September 5, 2007

Subject: *Source Removal Work Plan Addendum*
Earthgrains Baking Companies, Inc., 955 Kennedy Street, Oakland, California 94606
RO #0002569

SITE MAP SHOWING PROPOSED EXCAVATION AREAS
 EARTHGRAINS BAKING COMPANIES, INC.
 955 KENNEDY STREET
 OAKLAND, CALIFORNIA 94606

FIGURE:
12

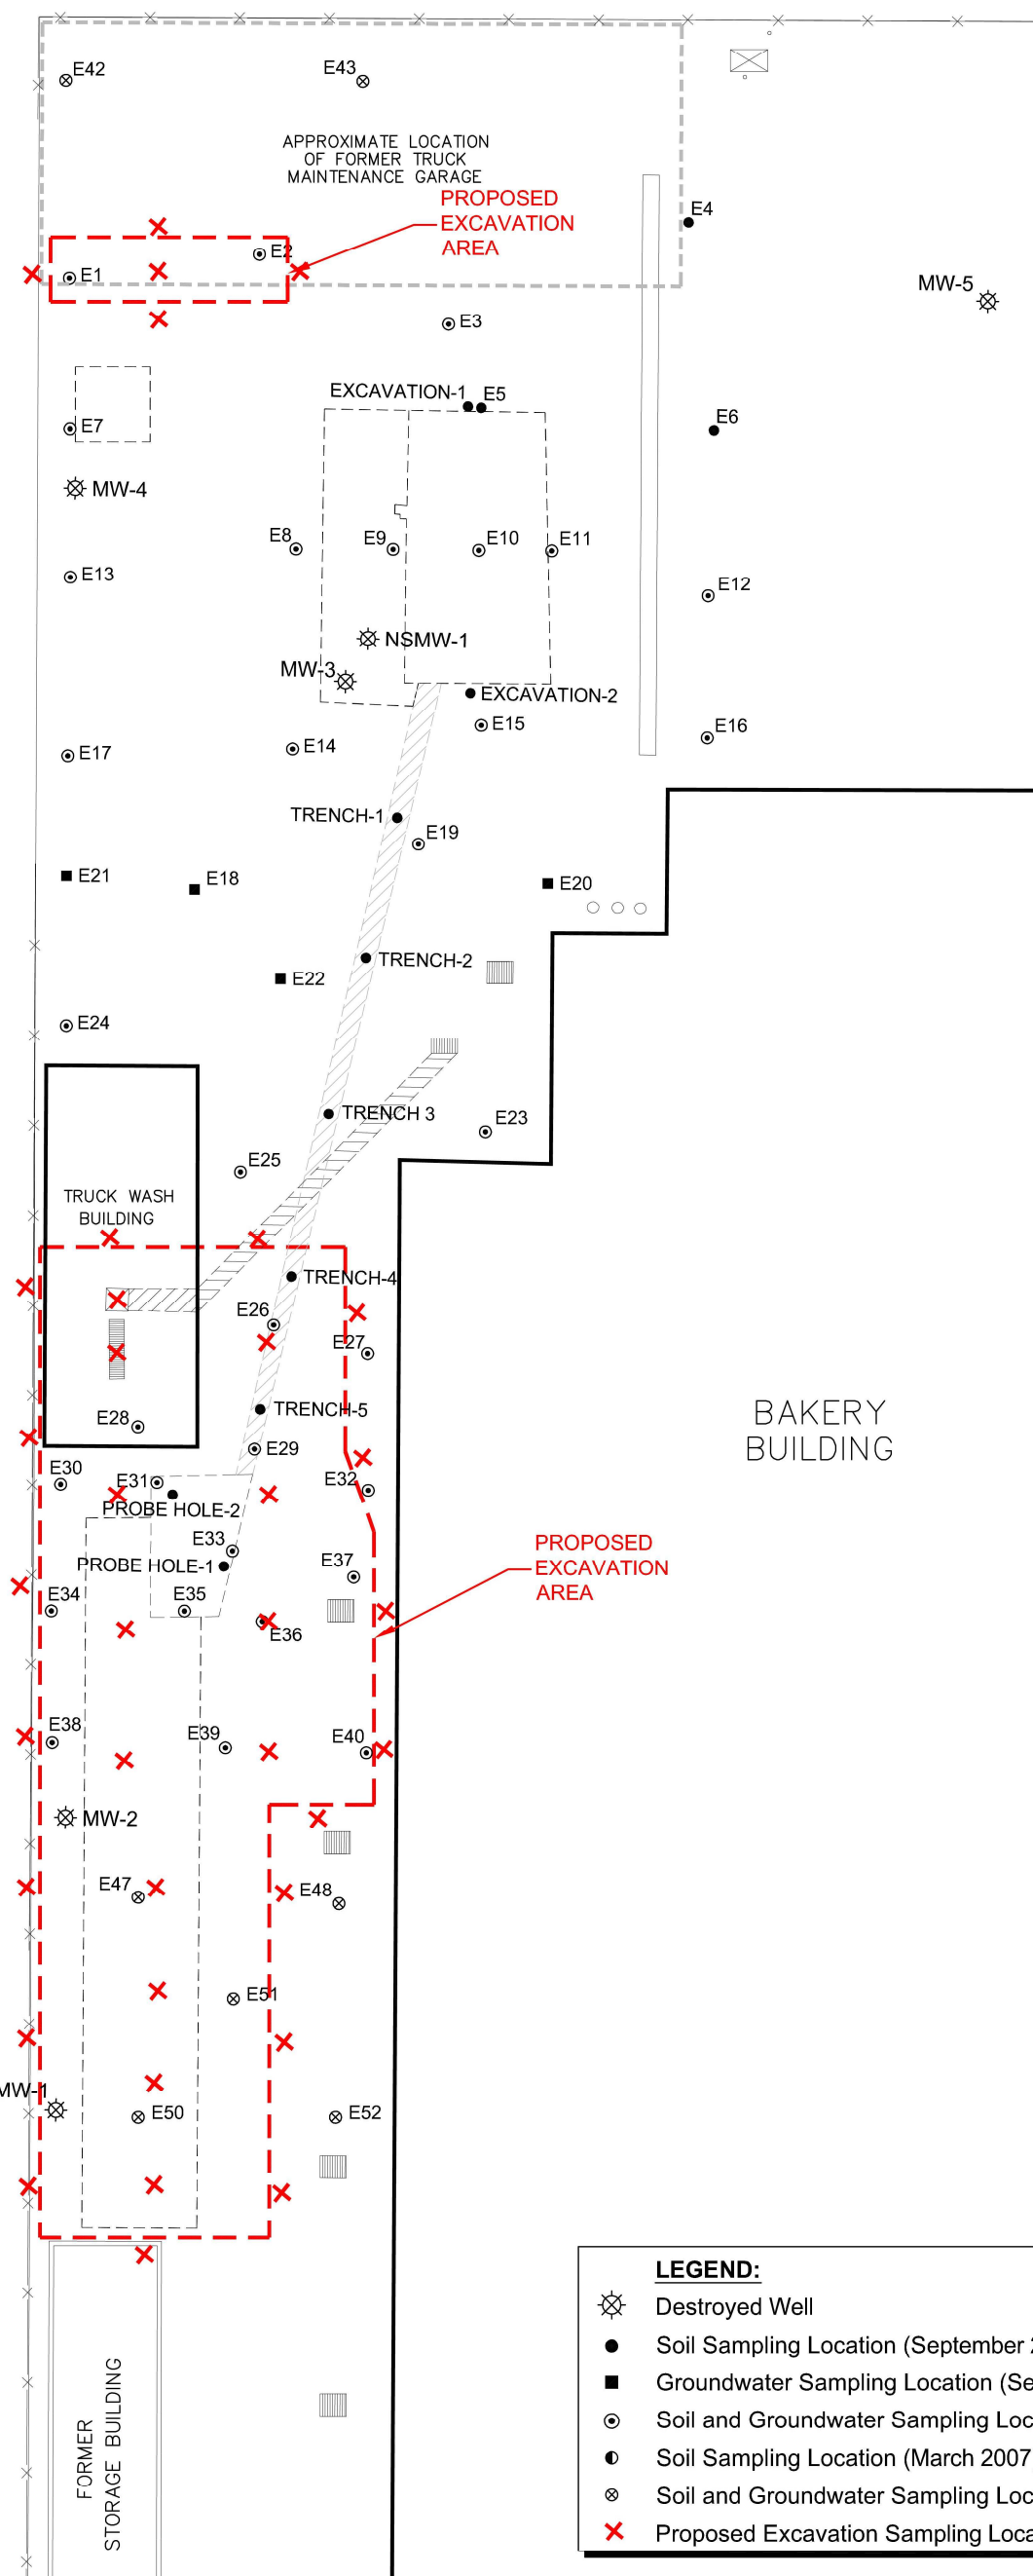
At your request, I am enclosing a revised version of Figure 12 from the Work Plan. The revised figure includes proposed excavation soil sampling locations. The proposed density of sampling is approximately one soil sample for every 20 linear feet of excavation sidewall and one soil sample for every 400 square feet of excavation floor. The actual sampling locations may be modified or additional samples may be collected based on field conditions and accessibility as the remedial effort progresses. Soil samples will be collected beneath the two components of the oil/water separator system, as shown on the figure. Also, a proposed excavation sidewall sample along the northern excavation boundary coincides with the location of the basket washer discharge pipeline that drains into the oil/water separator system. Should any other pipelines be encountered in the excavations, they will either be removed (if not in use) or reinstalled following excavation activities (such as a storm sewer pipeline).
